**From:** DIO ODC-IPS SG2a  
**Sent:** 19 September 2014 09:54  
**To:** Air-1Gp-BM Cap Safeguarding WO Air-1Gp-BM ATM Intra SO3  
**Subject:** FW: Hill of Lychrobbie wind turbines  
Hi Both,

**From:** [redacted]  
**Sent:** 18 September 2014 16:43  
**To:** DIO ODC-IPS SG2a  
**Cc:** [redacted]  
**Subject:** Re: Hill of Lychrobbie wind turbines

The attached plan shows our understanding of the local situation for reference (Burn of Whilk in red, operational turbines in blue, Hill of Lychrobbie in yellow).

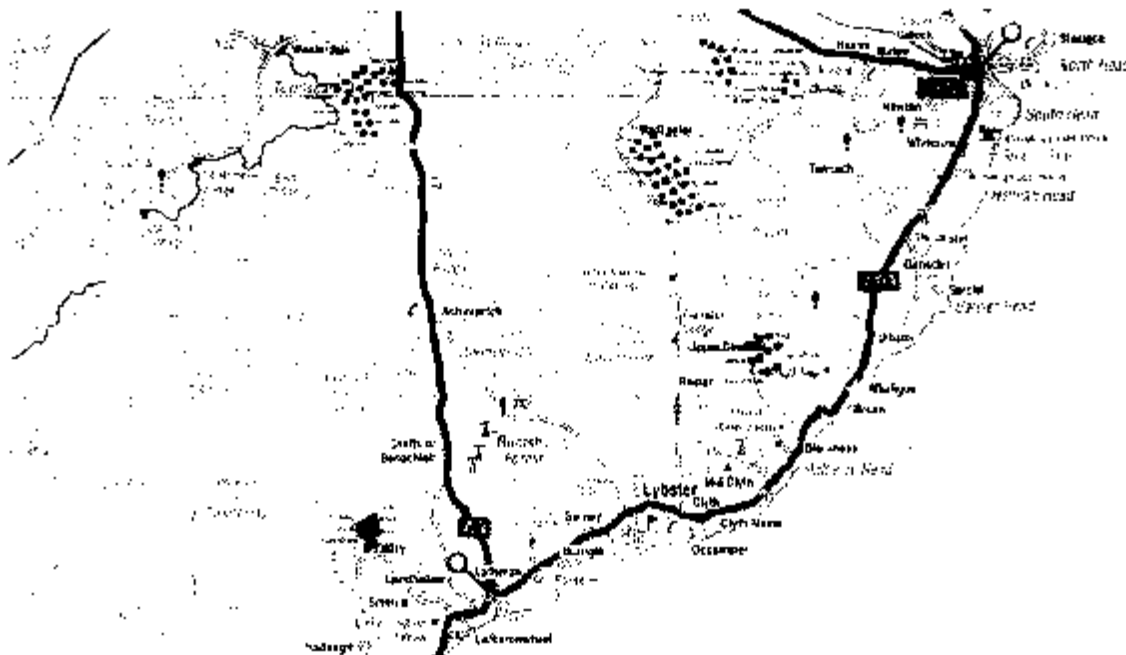
I understand that the review of RAF Lossiemouth by 1 Gp Safeguarding SMEs in May 14 identified issues with the operational turbines in the vicinity of the Burn of Whilk development, which is currently under construction. It seems to us that the operational impact of the Houstry / Buo-fruch turbines, about 3km north of Lychrobbie, is equally if not more relevant to our project. Given that the SMEs presumably assessed Houstry / Buo-fruch during their review of RAF Lossiemouth, we'd appreciate a summary of their conclusions.

The other follow up question I had was whether mitigating the detectability of the Hill of Lychrobbie project could be possible and might address operational concerns. We may be able to line up the turbines for example so they 'hide' behind each other when viewed from the radar, or drop from 3 to 2 turbines if that made a difference to the returns / interference.
